**TOWN OF BAY HARBOR ISLANDS  
PLANNING AND ZONING BOARD**

1. Request for approval for a new single family home for "Yalin Izkah" located at 10110 East Broadview Drive, Lot 17 of Block 25. On March 3, 2020, the Board deferred the project. The architect has submitted revisions based on comments from the hearing. The owner is proposing to construct a new two story single family home. The proposed two story home has approximately 5,986 square feet of a/c living. The residence will have 4 bedrooms, 5 1/2 baths and a two car garage. Enclosed please find the site plan and elevations. (Item #1)

**TOWN OF BAY HARBOR ISLANDS  
COMMUNITY DEVELOPMENT  
MEMORANDUM**

**Subject:** Single-Family Residence – New Construction – Revision #1  
10110 E. Broadview Drive  
Deferred from Planning & Zoning Board Hearing March 3<sup>rd</sup>, 2020  
Bay Harbor Islands Acct. No.: SPR19-000006  
MMPA Acct. No.: 01-0702-1090

North & South Side  
Perimeter Fence & Wall

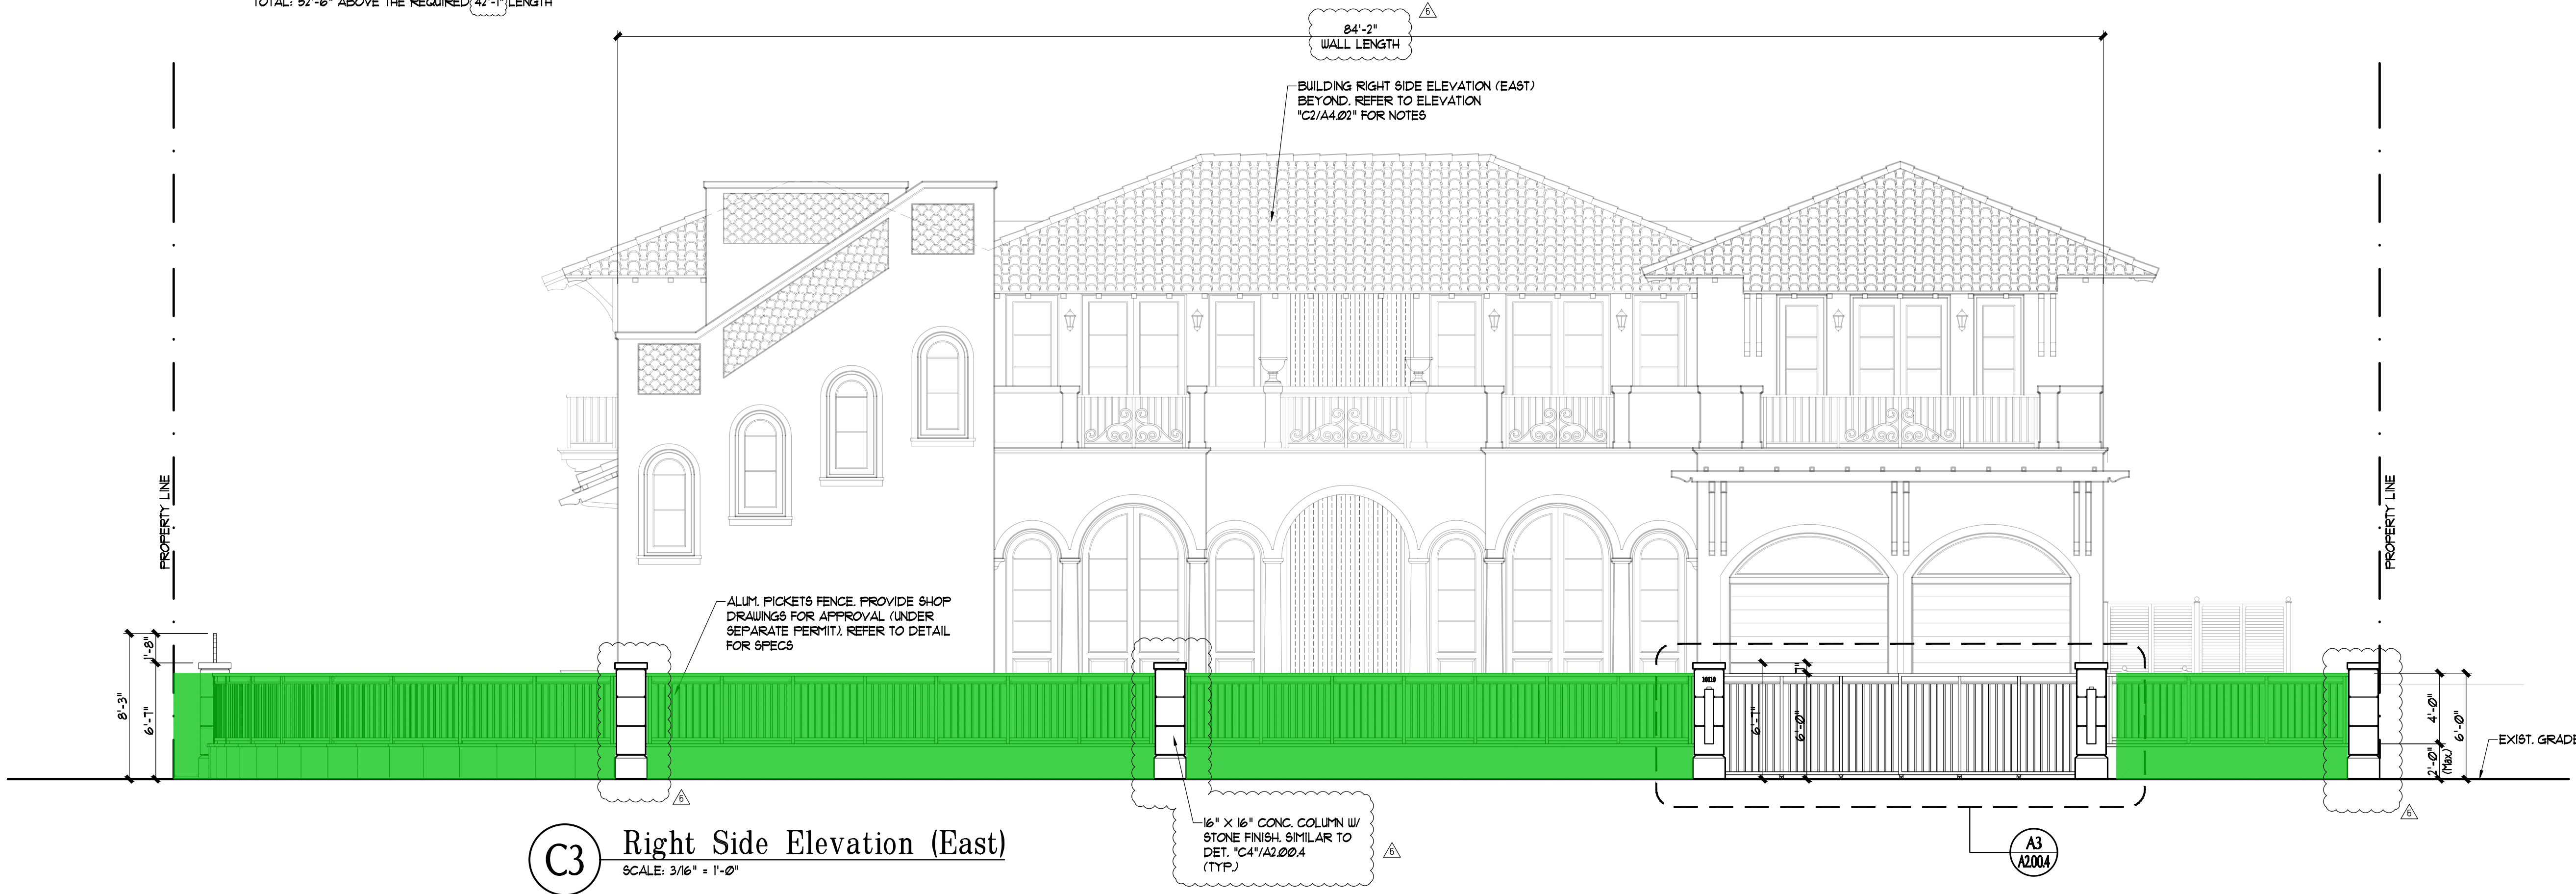
1. Removed proposed 4' aluminum picket fence along the west and north property lines and replaced with a 6' high CMU stucco privacy wall and columns. Added stone cap columns at the corners and within perimeter of the fence.

PROJECT YR.: 2019 CAD DWG FILE: Izhak  
DRAWN BY: R. R. CHECKED BY: R. J.  
SHEET TITLE  
Gate Elevations & Sections

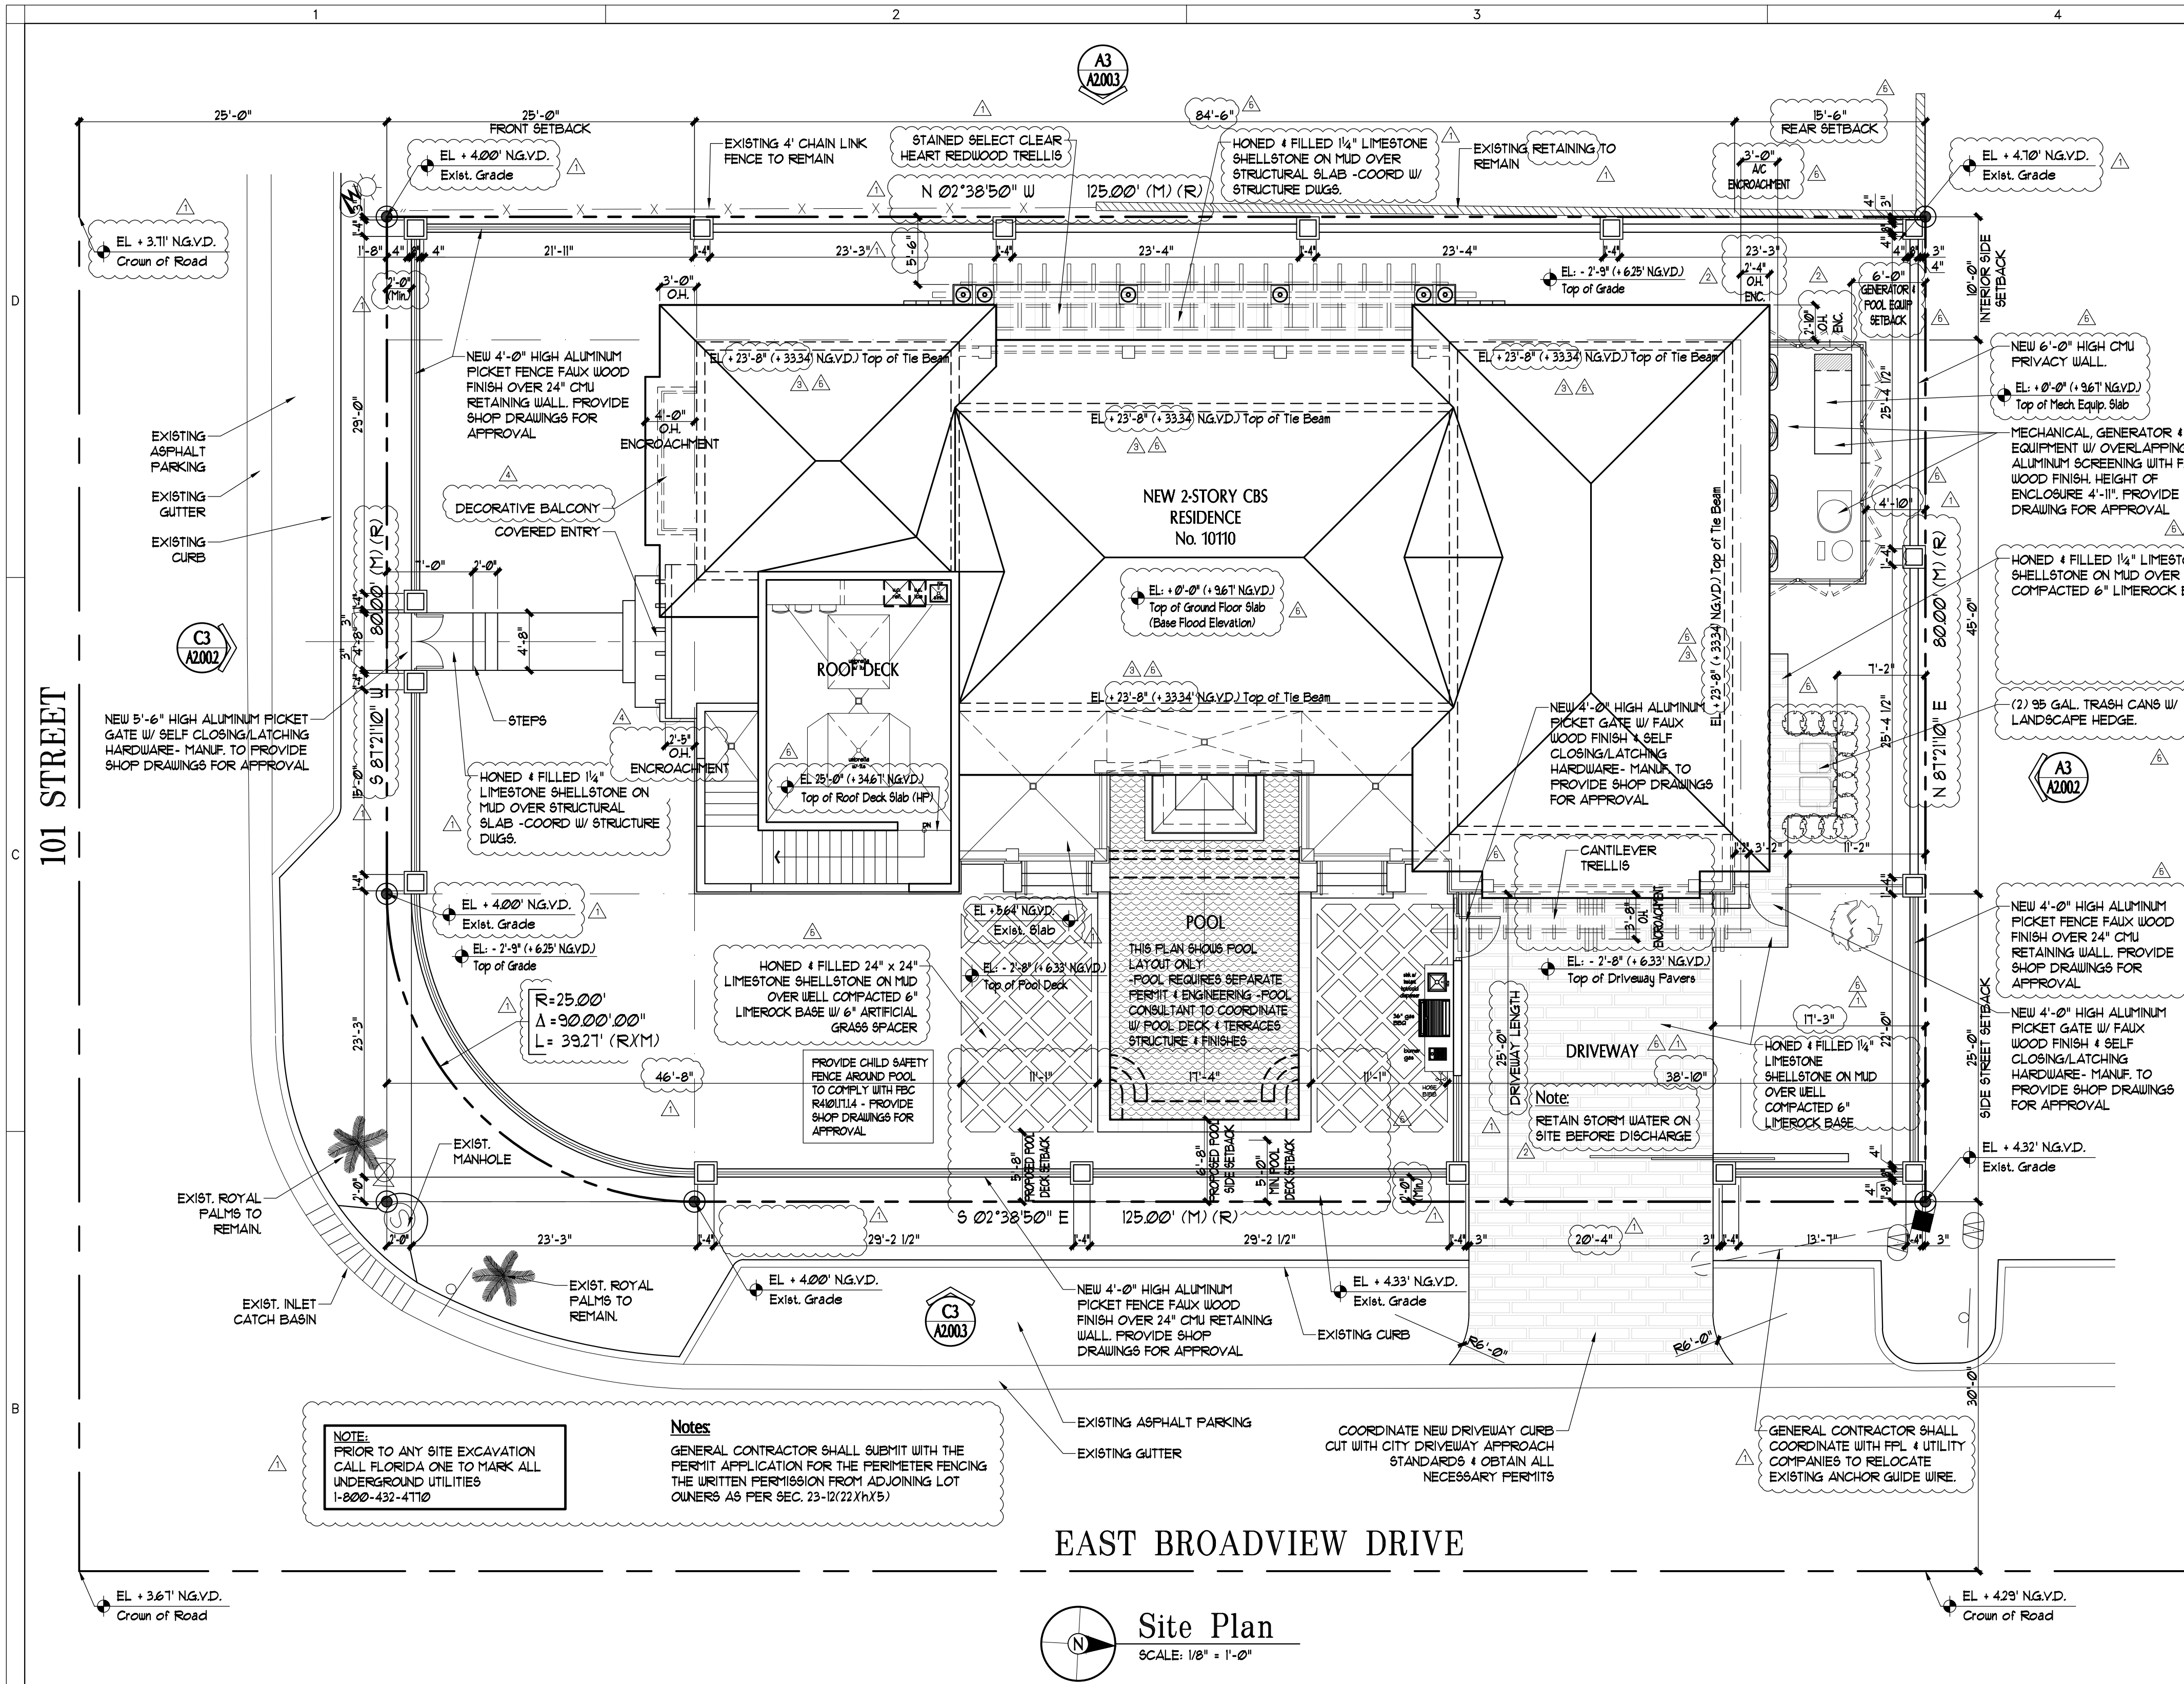
7. Increased Gate Pillar column height on 101<sup>st</sup> Street Gate Entrance from 6'-5" to 6'-7".
8. Pool deck detail has been added to the bottom of Sheet A2.00 Site Plan. This shows the color and layout of the proposed deck.
